ADDENDUM NO. ONE

AB2013-25B

**TERMINAL PARKING AREA AND ACCESS IMPROVEMENTS (REBID)  
AT TRENTON-MERCER AIRPORT AB2013-25B  
ADDENDUM NO. ONE**

**ELECTRICAL  
SITE PLAN**

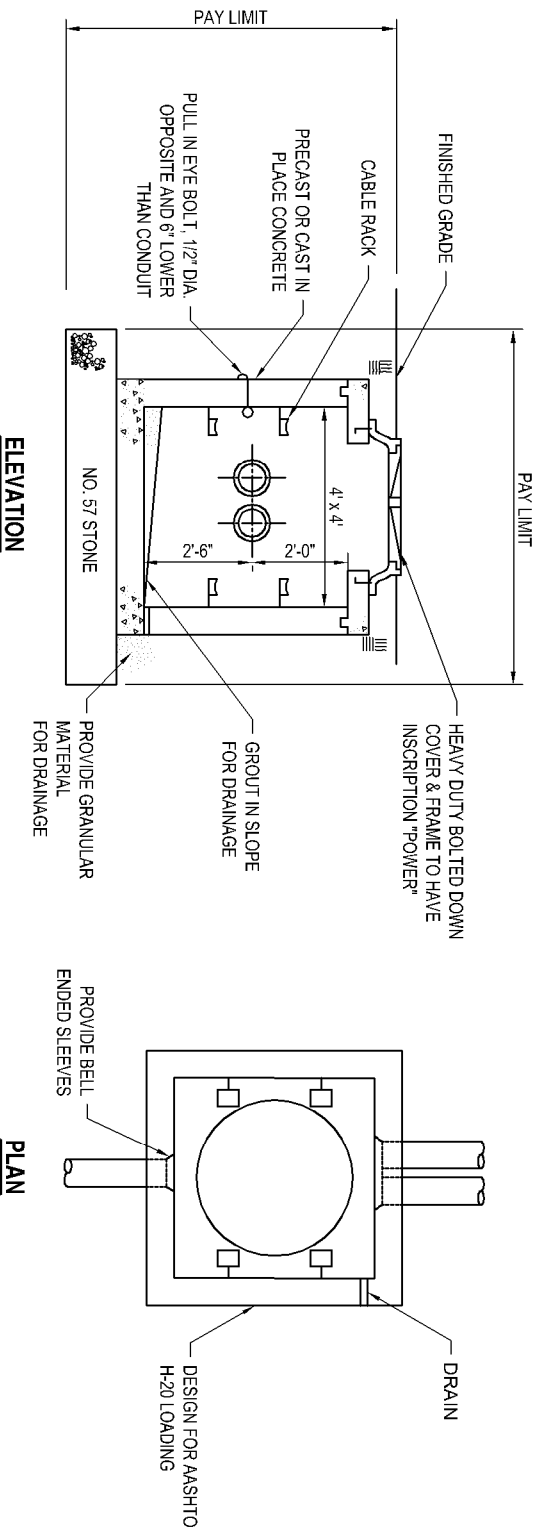
1. On DRAWING GI002, **DELETE** BASE BID Quantity Tables and **SUBSTITUTE THEREFOR** the attached BASE BID Quantity Tables.
2. **DELETE** DRAWING EL101 in its entirety and **SUBSTITUTE THEREFOR** attached replacement drawing EL101 (Revised 7/10/13). Revisions to the drawing consist of changes to conduit sizes and proposed power cabling to be installed in each conduit.

**A1 ELECTRICAL HANDHOLE DETAIL**

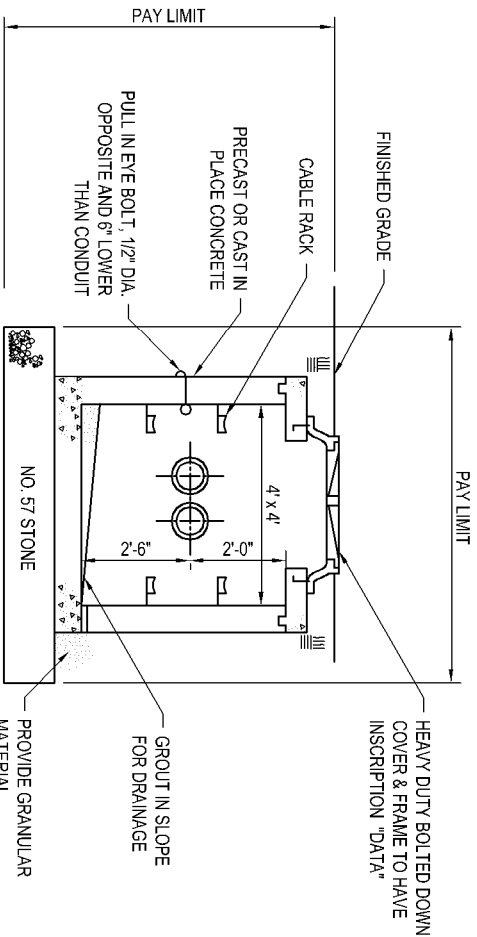
3. On DRAWING EL501, **DELETE** Detail A1, "ELECTRICAL HANDHOLE DETAIL", and **SUBSTITUTE THEREFOR** the attached revised Detail A1. The detail was revised to include dimensions and clarification of pay item.

1. PULL BOX AND COVER TO BE DESIGNED TO H-20 LOADING UNLESS OTHERWISE NOTED.
2. REFER TO SITE PLAN FOR CONDUIT QUANTITY AND SIZE.
3. ALL HANDHOLES SHALL BE PAID FOR UNDER JUNCTION BOX ITEM.

**C3 DATA HAND HOLE DETAIL**

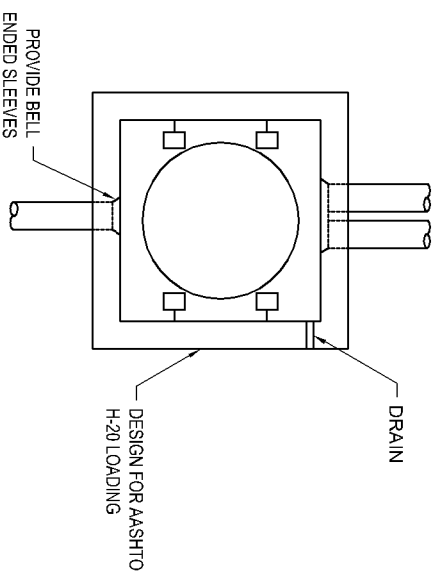
4. On DRAWING EL502, **DELETE** Detail C3, "DATA HANDHOLE DETAIL", and **SUBSTITUTE THEREFOR** the attached revised Detail C3. The detail was revised to include dimensions and clarification of pay item.

1. PULL BOX AND COVER TO BE DESIGNED TO H-20 LOADING UNLESS OTHERWISE NOTED.
2. REFER TO SITE PLAN FOR CONDUIT QUANTITY AND SIZE.
3. ALL HANDHOLES SHALL BE PAID FOR UNDER JUNCTION BOX ITEM.
